**Pacific Gas and
Electric Company®**

PG&E Letter DCL-12-017

Docket No. 50-275, OL-DPR-80
Docket No. 50-323, OL-DPR-82
Diablo Canyon Units 1 and 2

Response to NRC Request for Additional Information regarding PG&E Letter
DCL-11-059, "License Amendment Request 11-04, Revision to Technical
Specification (TS) 3.6.6, 'Containment Spray and Cooling Systems,' TS 3.7.5,
'Auxiliary Feedwater (AFW) System,' TS 3.8.1, 'AC Sources - Operating,' TS 3.8.9,
'Distribution Systems - Operating,' and TS Example 1.3-3"

FIGURE 15.4.2-13
 MAIN FEEDLINE RUPTURE
 WITH OFFSITE POWER AVAILABLE
 STEAM GENERATOR PRESSURE AND
 TOTAL MASS TRANSIENTS

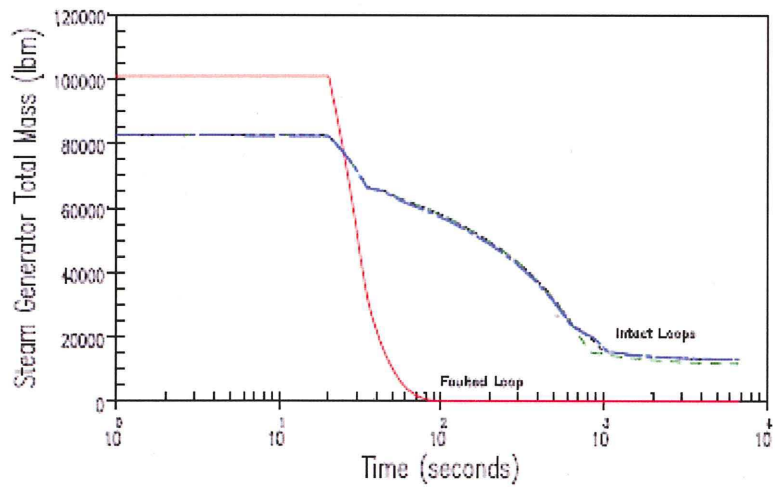
The feedline rupture accident does result in a faulted and depressurized SG. Therefore, PG&E performed additional evaluations of the AFW system performance to demonstrate acceptable accident mitigation with one LCV on each MDAFW pump incapable of automatically throttling for runout protection as designed. In TS 3.7.5 Condition B, each MDAFW pump would still have one LCV capable of automatic throttling. The limiting plant condition that occurs during a feedline rupture occurs when the faulted SG is completely depressurized. However, the feedline rupture initiates a rapid main steam isolation signal that automatically isolates the intact SGs from the fault. As shown in FSARU Figure 15.4.2-13, the intact SGs then pressurize to the lowest main steam safety valve setpoint to provide secondary steam heat removal well before the faulted SG is completely depressurized. PG&E has performed evaluations of the AFW system performance to establish that the single operable LCV on each MDAFW pump is still capable of preventing adverse pump runout conditions for the limiting single failures assumed in the FSAR accident analyses.

The statement in DCL-11-059 is clarified as follows:

“For the accidents that require evaluation below for acceptable AFW function while in the applicable proposed Technical Specification Action due to inoperable automatic control of MDAFW LCVs, no additional equipment failures beyond the limiting single failures assumed in the FSAR accident analyses are required to be postulated when demonstrating the safety function is still maintained.”

Table 1 provides a summary of the AFW system single failure evaluation for a feedline rupture accident while in the specific plant configuration allowed by the TS 3.7.5, Condition B. The Base Case shows the normal AFW system performance with no failures while the other three cases show the performance for the limiting three active system failures evaluated. The evaluation is performed for a feedline rupture accident that has occurred on SG 3, which has the most limiting system hydraulic resistance. The FSARU feedline rupture analysis conservatively does not credit any AFW flow for the first ten minutes, until after the operators have manually isolated the faulted SG. Therefore, the values provided in Table 1 represent the AFW flow that would be available to the intact SGs for each single failure case after the faulted SG is isolated. Table 1 demonstrates that the limiting Case 1 failure of the TDAFW pump still ensures one MDAFW pump provides the minimum 390 gpm flow to two intact SGs. These evaluation cases maintain additional conservative margin since no credit is taken for any MDAFW 3 pump flow to SG 4, which could be provided in Cases 1 and 2 after the faulted SG 3 is isolated.
